Your ref: 2012/5825/P

Our ref: CG/08264

8 Pilgrim's Lane

Please see below our review of the Basement Impact Assessment undertaken and counter argument existing for 8 Pilgrim's Lane. We provide initially our independent review of the site investigation data, ground conditions, and potential impacts of the proposed development. Subsequently we provide comment on the previous submissions received.

Title Sketch of basement and party wall structures	Figure 3
---	--	-----------------

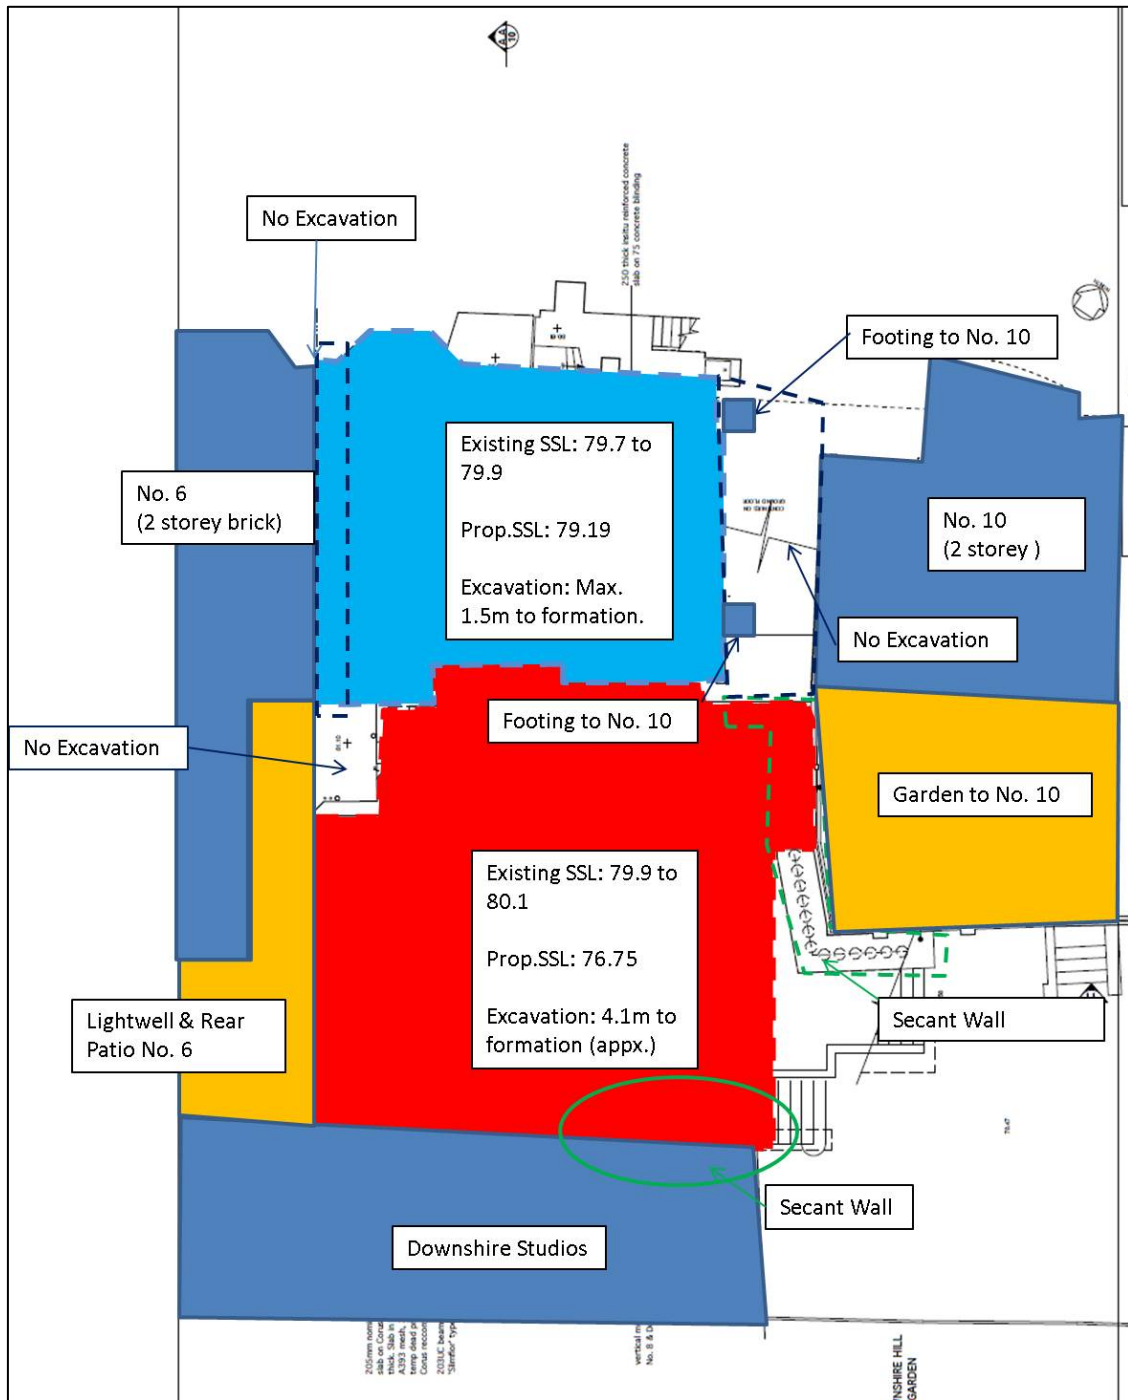
The property shares party wall boundaries with No. 10 Pilgrim’s Lane to the north, No. 6 Pilgrim’s Lane to the south, and Downshire Studios to the east. The new basement level has been located such that it is immediately adjacent only to Downshire Studios, single storey properties, to the east. A ‘cartoon’ plan showing proposed dig depths relative to party wall footings is provided in Figure 3. The perceived impacts are summarised in Table 3, these are relevant to the ‘Land Stability’ section of CPG4ⁱⁱ.

Location	Proposed construction	Perceived impact
Party Wall with No. 6 (Western section adjacent to single storey basement)	Ground floor to be lowered by between 400mm to 600mm. Requires excavation of between 725mm to 925mm assuming floor slab construction thickness of 325mm. 0.5m wide strip left adjacent to No. 6 that is not excavated.	LGC trial pits TP01 and TP02 are on internal walls. No investigation of party wall depth. If foundation depths are assumed to be similar to those recorded elsewhere (e.g. 1.0m and 1.2m) then excavation does not affect stability in the short term and underpinning is not required. Recommend PW 6 foundation depth is confirmed by trial pit.
Party Wall with No. 6 (Eastern section adjacent to	Basement excavation in this area is some 4.1m to formation. Existing flank wall, between 6 & 8 is to be	The structure of No. 6 is offset by some 1.5m from the basement boundary at this point and could

double storey basement)	underpinned to a depth of some 5.3m. Total retained height is 5.3m.	potentially be affected by ground movements during the deep, two stage underpinning. The area between the basement and No. 6 appears to be laid to concrete paving.
Party Wall with Downshire Studios. (Southern section underpinned)	Basement excavation is 4.1m to formation. Downshire Studios directly underpinned. Retained height approximately 2.5m (assumed)	Downshire Studios to be directly underpinned. Foundation depth currently not known.
Party Wall with Downshire Studios. (Northern section secant pile wall)	Basement excavation is 4.1m to formation (approx.) Secant wall constructed offset from Downshire Studios. Retained height approximately 2.5m (assumed)	Secant piled wall installation causes ground movements that should be taken into account in ground movement analysis, Downshire Studios structures will surcharge the wall and this should be accounted for in ground movement analysis.

Party wall with No. 10 (Western Section adjacent to car port)	No excavation immediately adjacent to No. 10 structure. Excavation 2.5m distant to a maximum depth of some 925mm. Current proposals show underpinning for ½ length of this wall.	First floor of No. 10 extends across to No.8 and is supported on two columns adjacent to No. 8. These two columns are likely to be on strip foundations however they have not currently been investigated. Depending on formation level, these could potentially be undermined during deepening of the basement of No. 8.
Party wall with No. 10 (Eastern Section adjacent to garden wall)	Secant piled wall and excavation of 4.1m approximately.	Area remote from structure of No. 10, but could potentially affect garden wall and garden through movements caused by secant wall installation and deflection during construction.
Internally – Structure of No.8	Excavation levels beneath the existing building vary considerably and consideration should be given to differential heave/settlement across the structure, and the potential to cause distortion.

It can be seen from Table 3 that the proposed construction generates potential risks to all of the party wall properties to varying degrees.
